RE: JMC Project 20029  
Edward Jones Office  
150 Bedford Road  
Town of North Castle, NY

**Response to Town Comments Submission**

**Town of North Castle Planning Department, July 4, 2020**

**Kellard Sessions Consulting, P.C. Memorandum, dated July 9, 2020**

( IN FEET )  
1 inch = 10 ft.

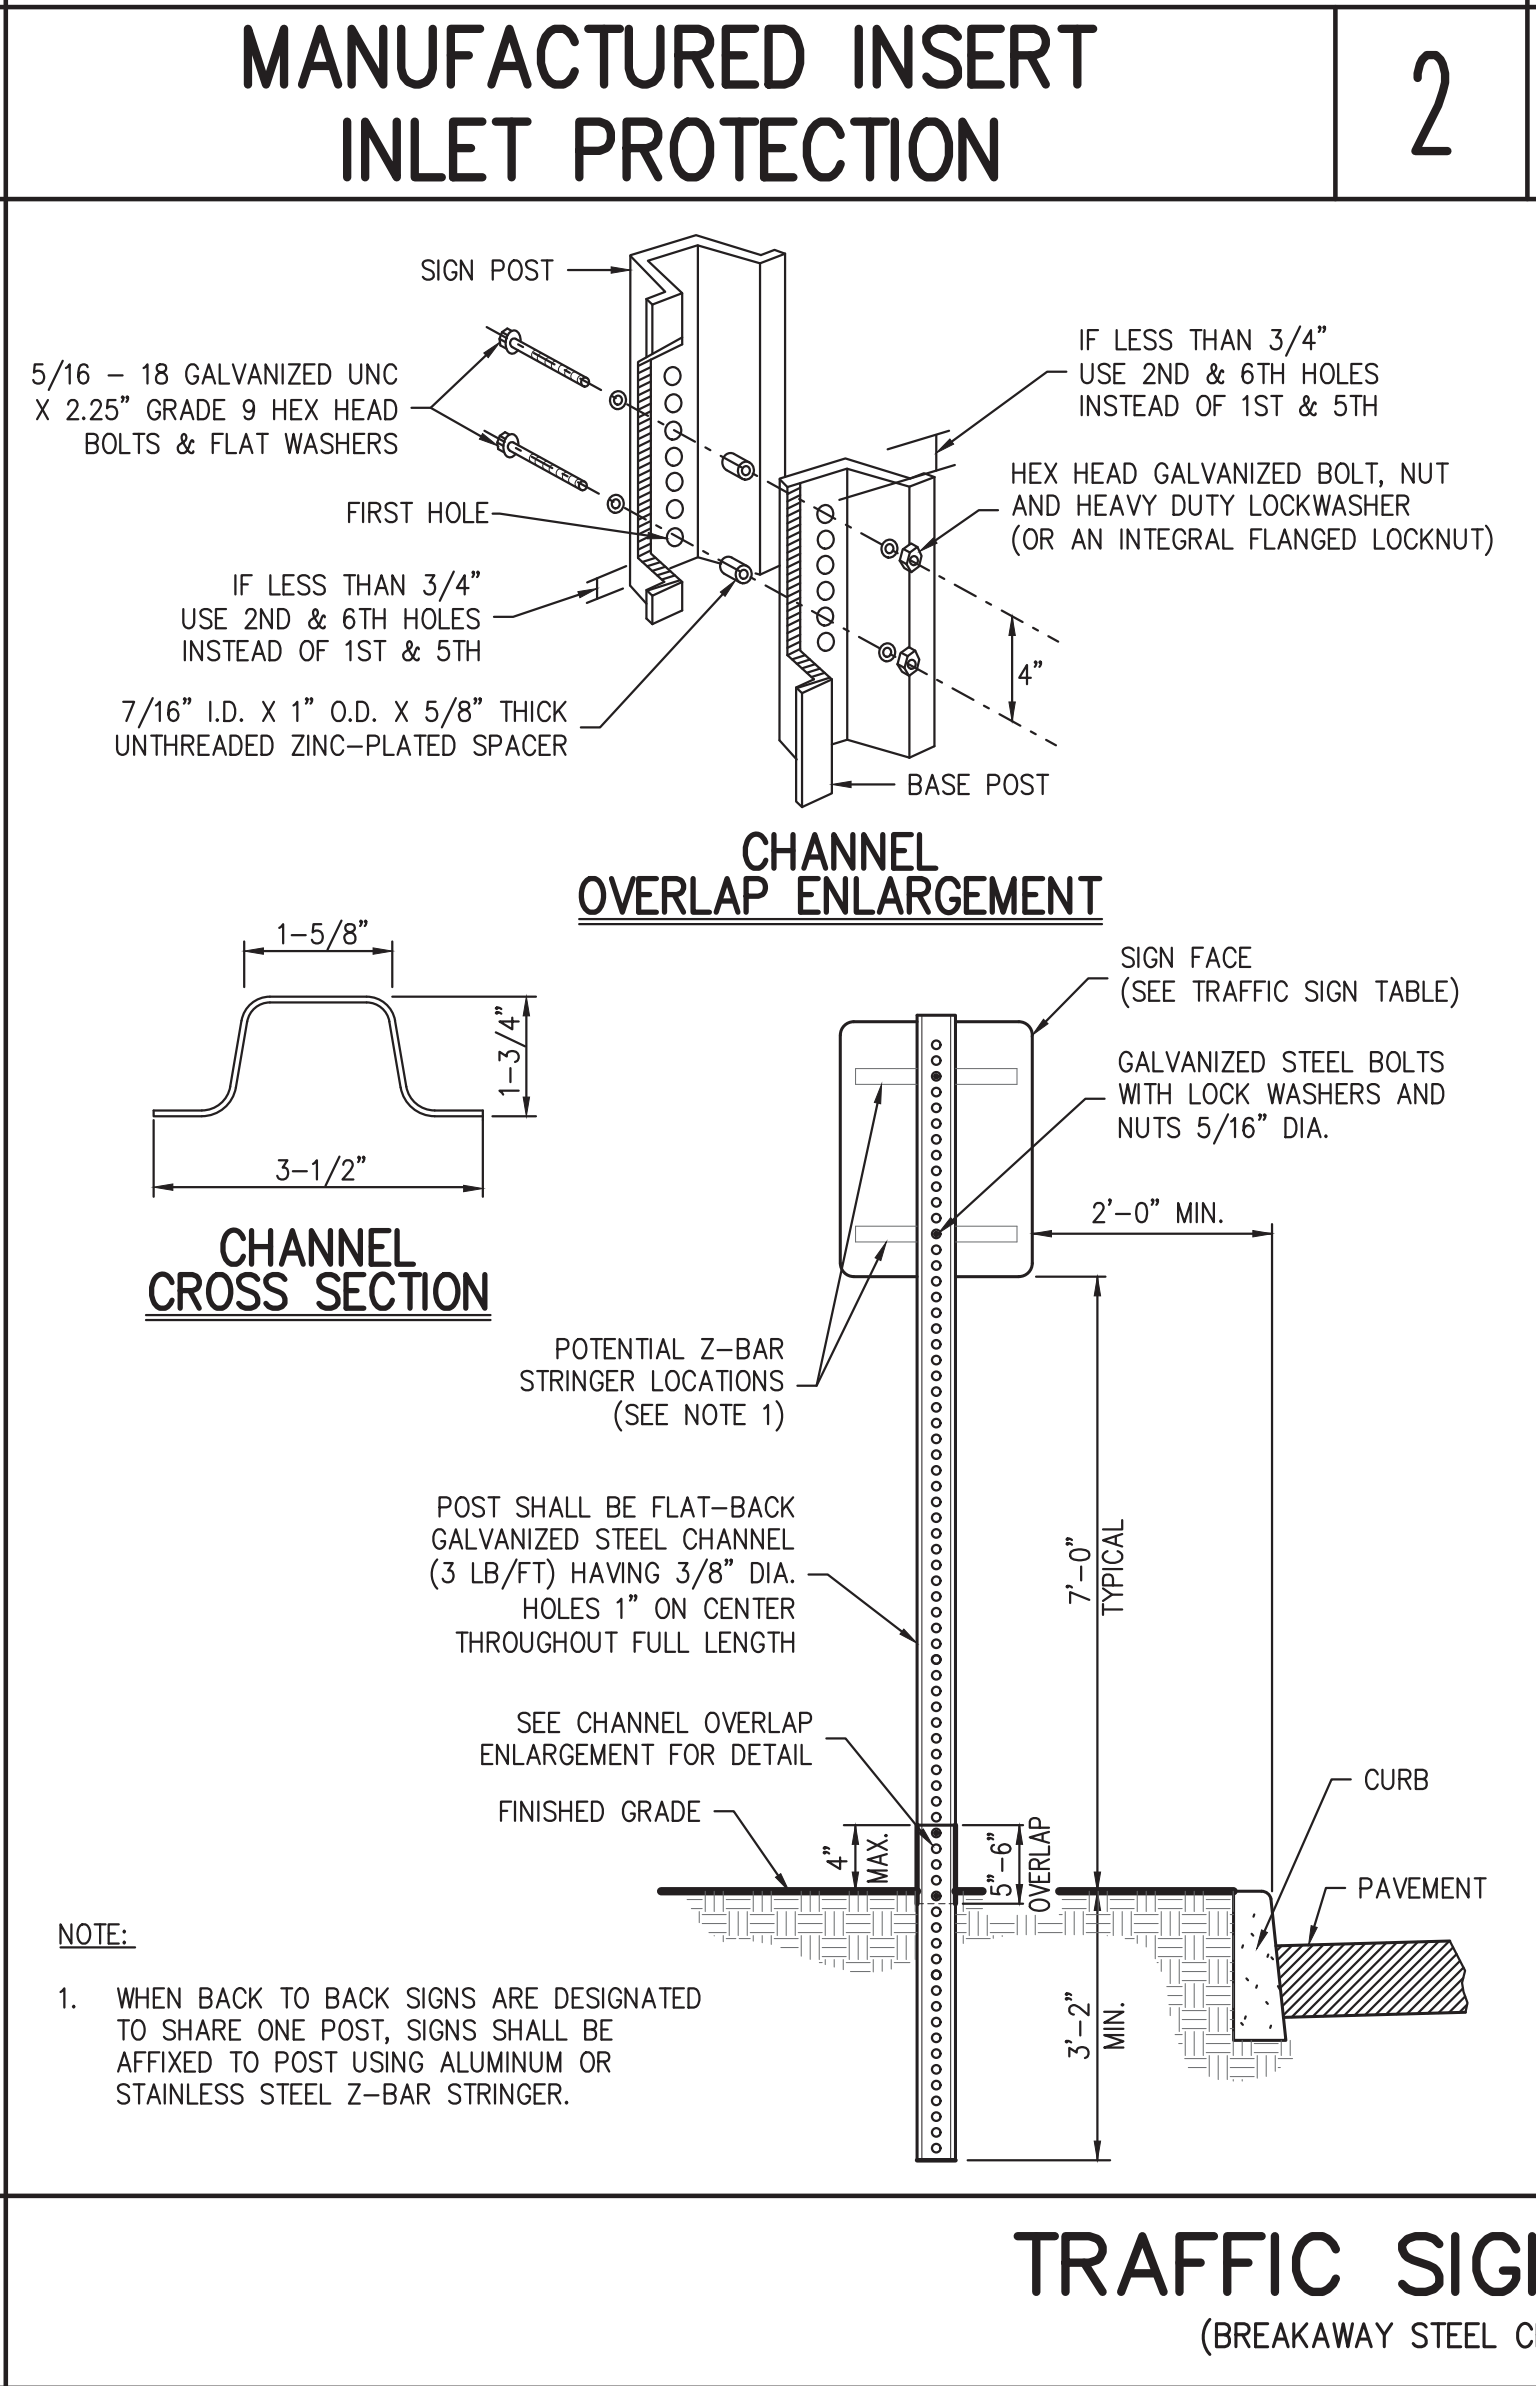
*The site plan shall be revised to depict the access drive dimensions in the vicinity of the new covered stairs on the eastern side of the building. Pursuant to Section 355-56.G. of the Town Code. The drive is required to be a minimum of 20 feet wide.*

*As previously noted, Section 355-56, G of the Town Code requires that access drives for parking areas serving between six (6) and twenty (20) spaces have a minimum width of 20 feet. The existing drive varies in width from approximately 12 to 15 feet. It appears an area variance will be required.*

*As previously requested, the plan has been revised to permit suitable access from the handicap access drive aisle to the ramp. However, the location of the “No Parking” sign shall be adjusted outside of the travel path.*

The access drive width has been dimensioned in the area of the proposed covered stairs. The width of the existing driveway has been determined to be existing non-conforming and will not be reduced in width under the proposed plan. Furthermore, based on the easterly curb location refinements and replacement the access drive has been increased to the maximum extent while also maintaining a planting bed along the easterly property line. The plan has been reviewed and approved by the Armonk Fire Department. Please refer to email correspondence from Armonk Fire Chief (Chief Phil Goulet), dated 07/07/2020.

The site plans have been revised to depict dimensions of the access drive, the width of which has not been reduced. Furthermore, based on the easterly curb location refinements and replacement the access drive has been increased to the maximum extent while also maintaining a planting bed along the easterly property line.

The site plans have been revised to relocate the proposed “No Parking” sign outside of the sidewalk travel path.
